Final Modification Report																
<h1>GC0151:</h1> <h2>Grid Code Compliance with Fault Ride Through Requirements</h2> <p>Overview: A letter issued by the ESO on 7th May 2021 and a presentation to be made to the 27th May 2021 GCRP have identified concerns about demonstrating compliance with the Fault Ride Through Requirements in the Grid Code. This proposal seeks to apply a workable, non-discriminatory, legally compliant solution based on Good Industry Practice to address this significant operational concern in an expedited manner.</p>	<h3>Modification process & timetable</h3>

<table><tr> <td>1</td> <td>Proposal Form 23 June 2021</td> </tr><tr> <td>6</td> <td>Final Modification Report 11 October 2021</td> </tr></table>

Figure 1 showing a theoretical worst case fault which plant has to be capable of riding through.

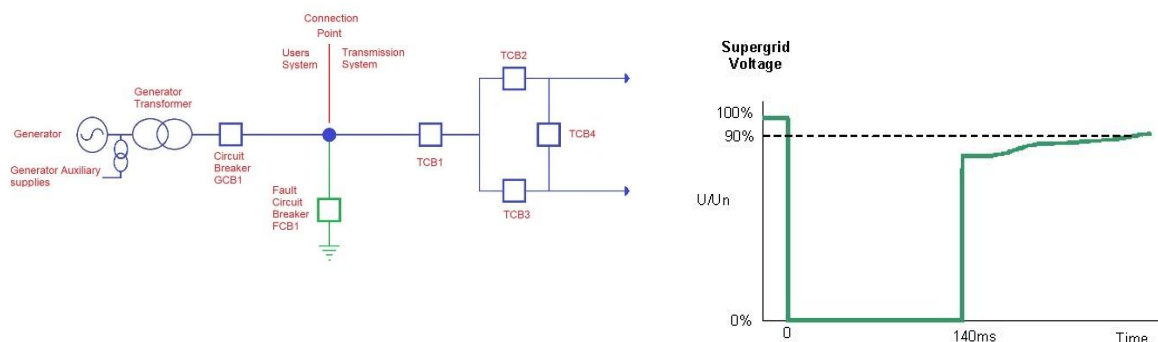
The new section CC.6.3.15(a)(i)(a) would only deal with plant capabilities by clarifying that it has to be capable of riding through the worst fault that the network could impose on the plant which is a 3-phase short circuit at the connection point which lasts for 140ms as shown in figure 1 below. To achieve this the words “be design to” will be added to section CC.6.3.15(a)(i)(a) as can be seen in the legal text contained in WAGCM2 and can be found in Annex 12.

Figure 2 showing a fault which can be cleared by transmission system breakers TCB3 & 4

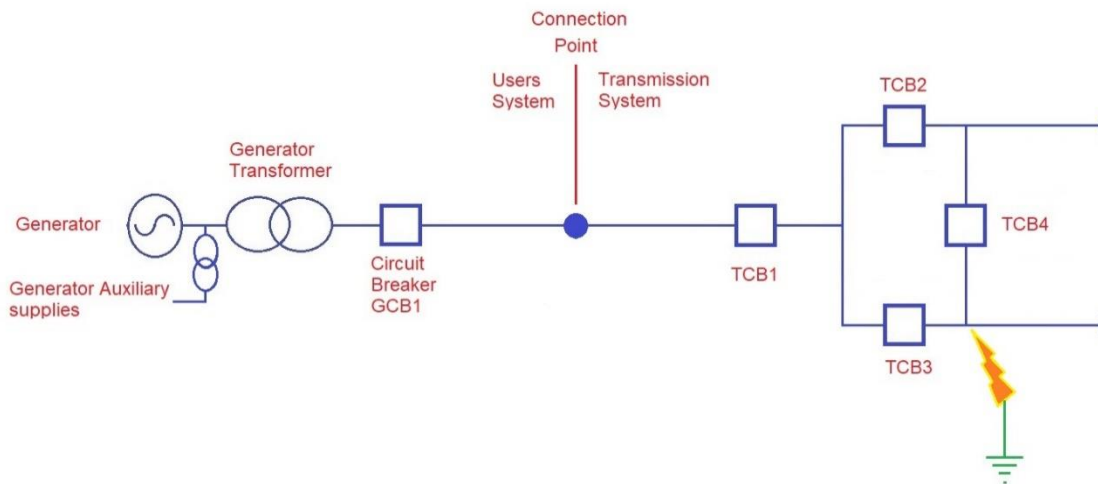
The new section CC.6.3.15(a)(i)(b) should deal with the actions to be taken in the event that a fault occurs firstly by requiring that plants ride through faults on the transmission system which can be cleared by transmission system circuit breaker as shown in Figure 2 below and by adding the following text as the introduction to the section:

- (b) Each **Generating Unit**, **DC Converter**, or **Power Park Module** and any constituent **Power Park Unit** thereof and **OTSDUW Plant and Apparatus** shall remain transiently stable and connected to the **System** without tripping of any **Generating Unit**, **DC Converter** or **Power Park Module** and / or any constituent **Power Park Unit**,

OTSDUW Plant and Apparatus, and for **Plant and Apparatus** installed on or after 1 December 2017, reactive compensation equipment, for any balanced and unbalanced fault where subjected to a voltage dip at the **Connection Point** where the voltage remains either on or within the envelope shown in figure CC.6.3.15(a)(i)(a) except where:

Figure 3 showing a fault which can only be cleared by Generator breakers GCB1

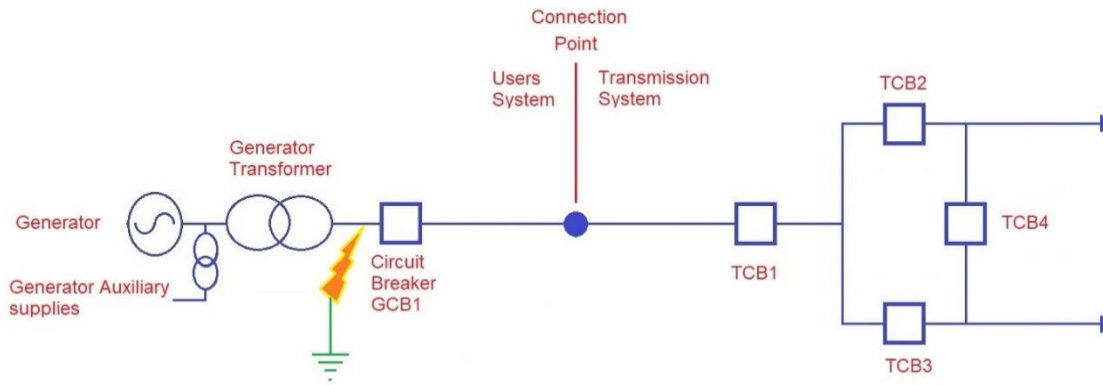
Firstly if the fault is on the Generator's equipment then the Generator shall be required to trip (normally circuit breaker GCB1 in the diagram above) to clear the fault from the transmission system as detailed in the proposed new sections CC.6.3.15(a)(ii)(b)(i) and ECC.6.3.15.8(vi)(i), as follows:-

the fault is on the **User's System**, when the **Generating Unit**, **DC Converter**, or **Power Park Module** and any constituent **Power Park Unit** thereof and **OTSDUW Plant and Apparatus** shall trip to clear the fault from the **Transmission System**. The protection schemes and settings should not jeopardise **Fault Ride Through** performance as specified in CC.6.3.15.1

Figure 4 showing a fault which can be cleared by Generator breaker GCB1 & transmission circuit breaker TCB1.

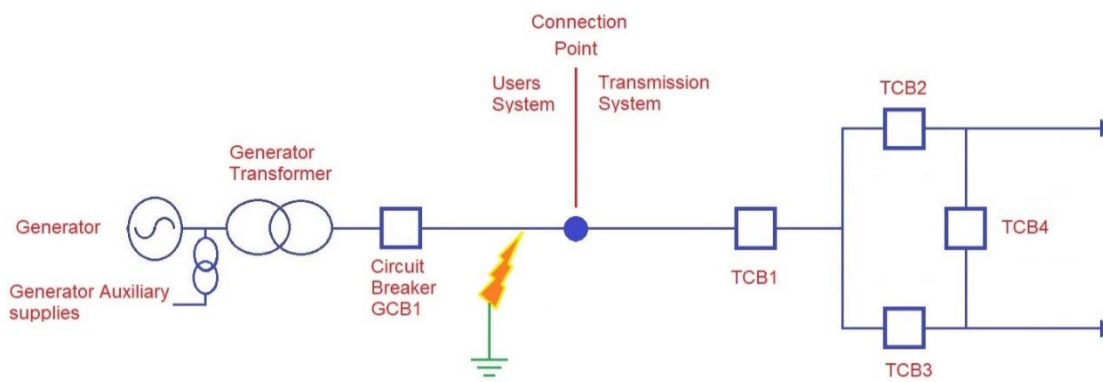
Secondly if the fault is at a location on the network that means that the fault can only be cleared by operation of both transmission and the Generator circuit breakers as shown in Figure 4, again the Generator will be permitted to trip to clear the fault as detailed in the proposed new section CC.6.3.15(a)(i)(b)(ii) and ECC.6.3.15.8(vi)(ii), as follows:-

the location of the fault means it cannot be fully cleared without tripping the of **Generating Unit, DC Converter, or Power Park Module** and any constituent **Power Park Unit** thereof and **OTSDUW Plant** shall trip as required.

Figure 5 showing a fault which can be cleared by transmission breakers TCB1,2&3, however this results in the Generator separated from the main transmission system and needs to be disconnected.

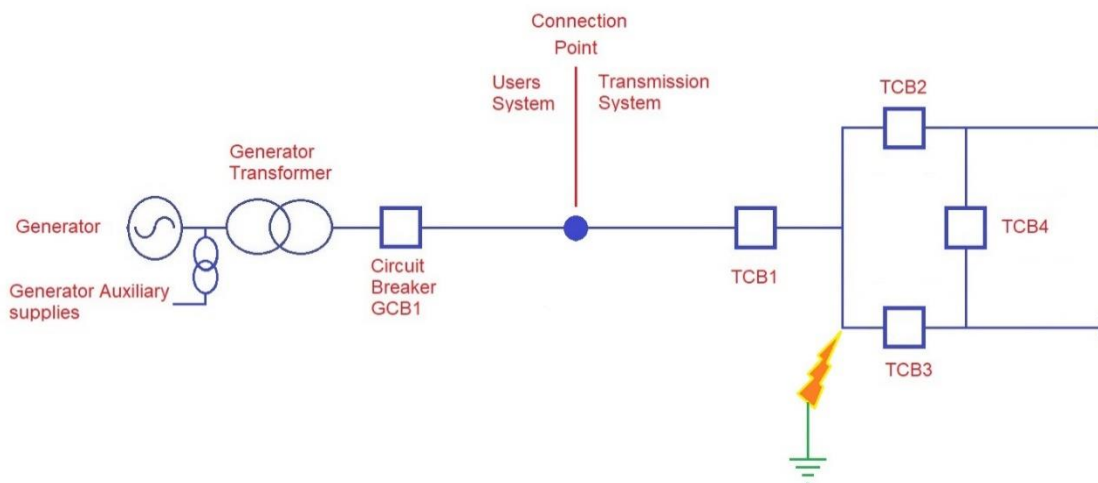
Thirdly if the fault is at a location on the network that means the Generator will become islanded by the operation of the transmission circuit breakers as shown in Figure 5 as detailed in the proposed new sections CC.6.3.15(a)(ii)(b)(iii) and ECC.6.3.15.8(vi)(iii), as follows:-

clearance of the fault results in the **Generating Unit, DC Converter, or Power Park Module** or **OTSDUW Plant** becoming islanded and disconnected from the **Total System** and not supplying **Customers** (where CC.6.3.7(c)(i) applies), then the **Generating Unit, DC Converter, or OTSDUW Plants** shall be permitted to trip as required.

Figure 7 showing the proposed reactive current injection requirements, requiring the current to always remain above the black line

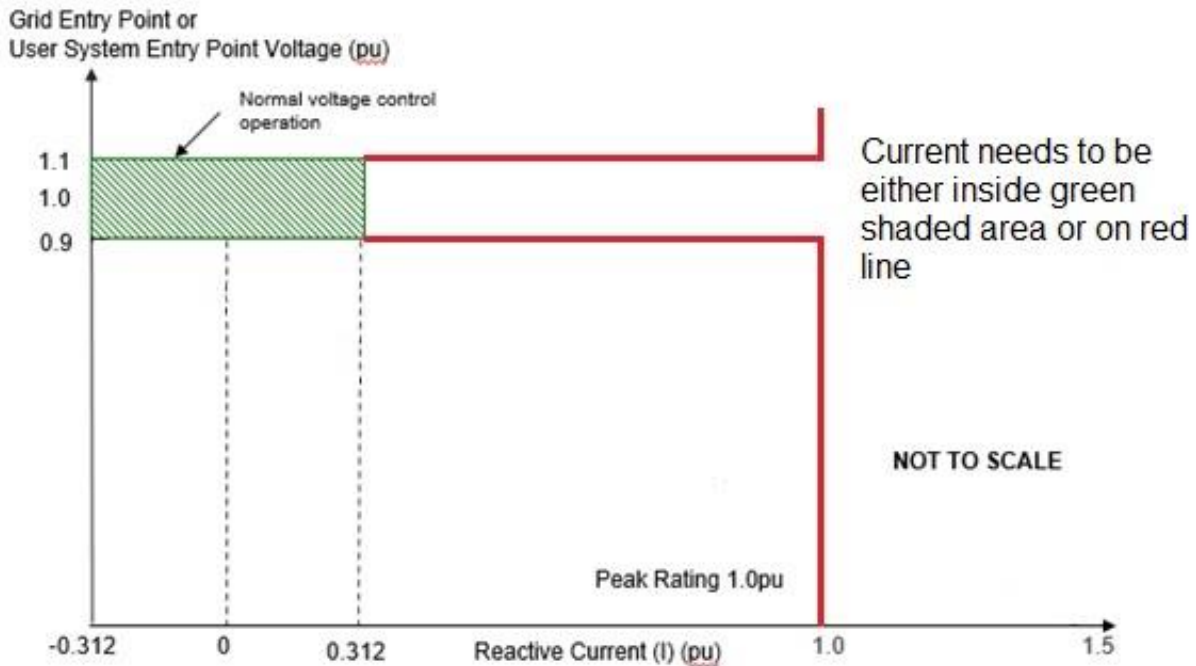
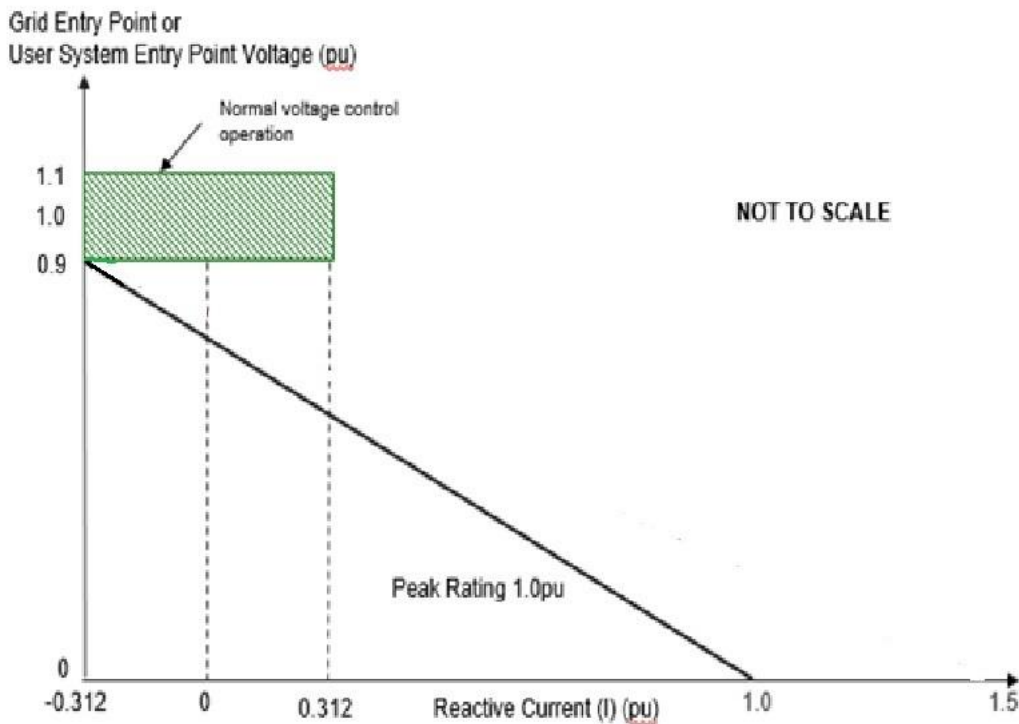
The area of the current (baseline) legal text which technically creates the biggest problem in relation to the ESO's letter of the 7th May 2021 are in sections CC.6.3.15 (a)(ii) and ECC.6.3.15.9.2.1(a)(i) which currently state "for which the voltage at the Grid Entry Point (or Interface Point in the case of OTSDUW Plant and Apparatus) is outside the limits specified in CC.6.1.4, each Generating Unit or Power Park Module or OTSDUW Plant and Apparatus shall generate maximum reactive current". If this requirement is drawn out on the figure 6 below where the reactive current and voltage must always either be within the green shaded area or on the red line.

This creates a particular problem in relation to the part of the ESO letter which requires Parties to confirm compliance as the Grid Code particularly FRT sections, because as drafted very few plants (if any) actually do this and this requirement has presumably drifted in as a drafting oversight relating to PPM requirements. This issue has previously been identified in the Workgroup GC0111 on Fast Fault Current injection and in the GC0137 VSM Workgroup and has been fixed for new PPMs, however currently all synchronous Generator and older PPM will technically be non-compliant with this FRT requirement as drafted. This issue was dealt with in GC0111 by adding a new figure as shown in Figure 7 and changing the text as follows.

- (iv) During the period of the fault as detailed in CC.6.3.15.1 (a) (i) for which the voltage at the **Grid Entry Point** (or **Interface Point** in the case of **OTSDUW Plant and Apparatus**) is outside the limits specified in CC.6.1.4, each **Generating Unit** or **Power Park Module** or **OTSDUW Plant and Apparatus** shall inject a reactive current above the heavy black line shown in Figure CC.6.3.15(b) without exceeding the transient rating limit of the **Generating Unit, OTSDUW Plant and Apparatus** or **Power Park Module** and / or any constituent **Power Park Unit** or reactive compensation equipment.

Figure 8 showing a typical active power response of a unit at low load to a fault

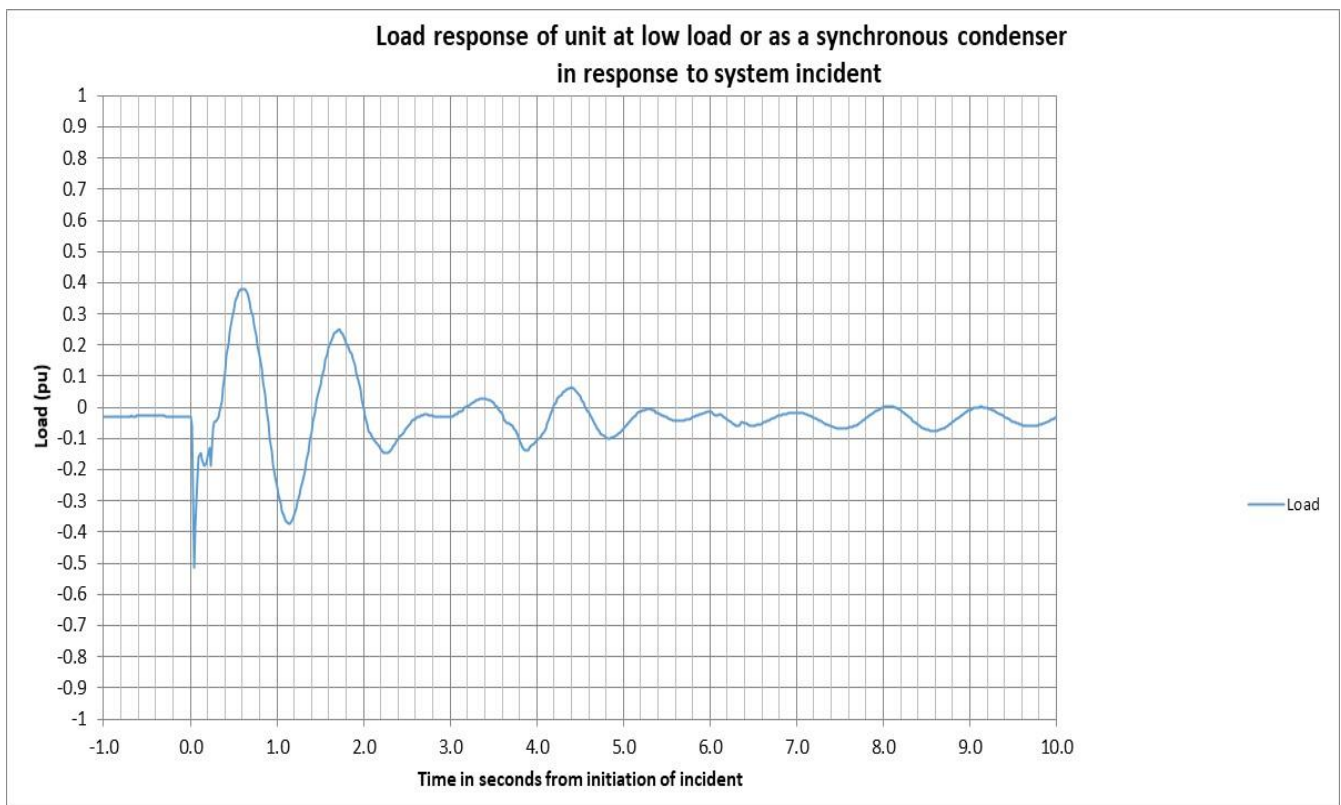
Whilst this works in principle at higher loads, it does create an issue at lower loads if at a real event for a unit operating as a synchronous condenser in figure 8.

When considering that the initial load is 0.02 pu; 90% of this is a very small number. It could be argued that it is difficult to carry out a sensible compliance assessment at these levels and it is hence suggested that the tolerance should be changed to 10% of rated capacity as follows
